COLORADO
Division of Reclamation,
Mining and Safety
Department of Natural Resources
1313 Sherman Street, Room 215
Denver, Colorado 80203

December 11, 2023

Re: Preliminary Review of a 112 Construction Materials Reclamation Permit Application Package, Ewing Gravel Pit, DRMS File M2023-033

Map Viewer

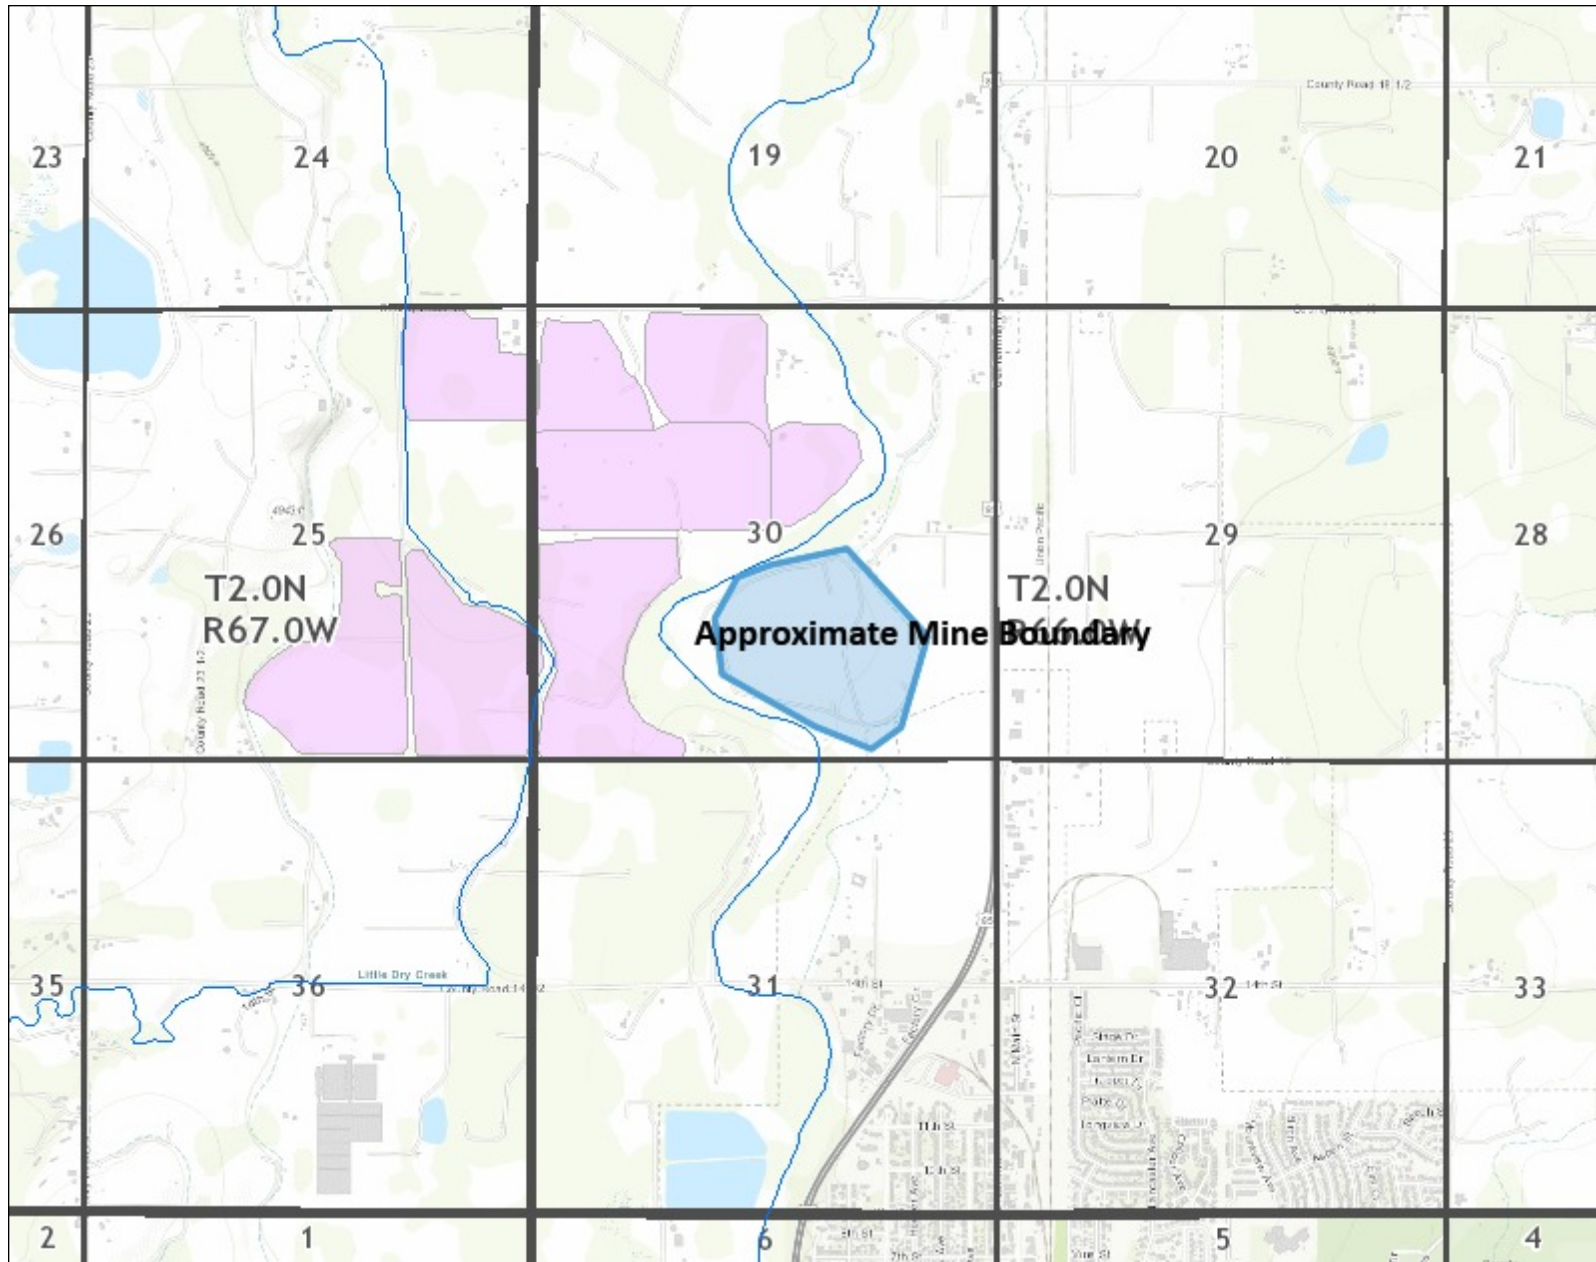
Additionally, according to the application and our records, there are several wells located on the subject property. Such wells must be operated in accordance with their permitted conditions and applicable statutes. Such wells cannot be used for the mining operation unless they are permitted for such use.

Additionally, in certain areas of the South Platte River Basin, SEO staff have observed groundwater problems that appear to be related to the lining of gravel pits located near streams, and in particular, these problems occur when multiple liners are located adjacent to each other. Attached is a map showing the location of this proposed mine and existing lined pits. DRMS should consider the siting and design of lined gravel pits to ensure that they will not individually or cumulatively result in impacts to the timing and quantity of groundwater flow from upgradient locations back to the stream system. In addition to impacts to property, such as flooding upgradient and reduced water levels downgradient of the liner, there are decrees of the court that specify the timing, quantity, and amount of water depleted from the streams by wells and accreted to the stream through recharge operations. The installation of a gravel pit liner should not result in changes to the timing, location, and amount of such groundwater flow. In the design and construction of the liner, the Applicant and DRMS should consider whether drainage structures are needed to allow water to flow back to the stream and to prevent water mounding behind the liner.

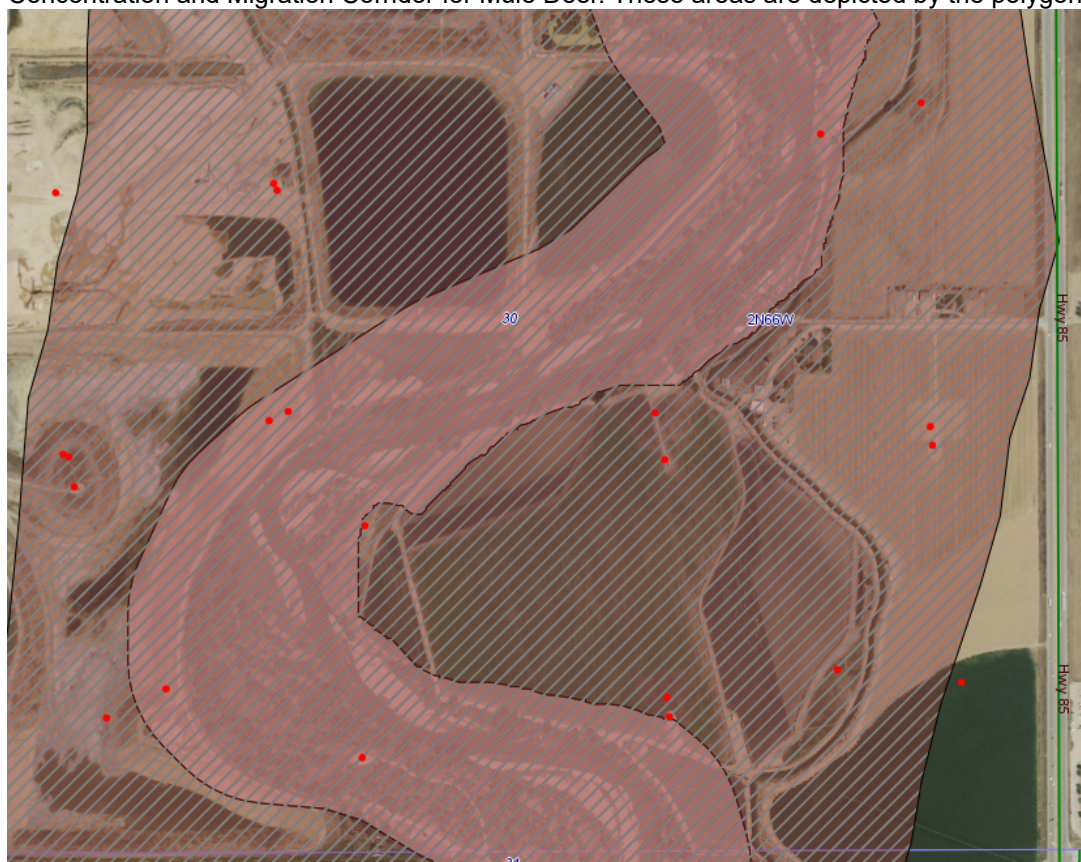
Ponds created by reclamation efforts could potentially have significant value to wildlife. To maximize this benefit, CPW recommends that ponds be designed to include irregular shorelines and one or more islands to provide cover, shelter, and nesting areas for migratory birds. Islands should be at least 15' x 25' in size for every two surface acres of water in the pond. Shoreline and island slopes should be graded to a ratio of 4 horizontal feet to every 1 vertical foot of distance, with some areas having slopes no steeper than 8 horizontal feet to every 1 vertical foot of distance. Such shallow areas will allow for the establishment of a variety of aquatic vegetation and invertebrate prey for waterfowl and shorebirds. Shorelines should be re-vegetated with native aquatic vegetation.
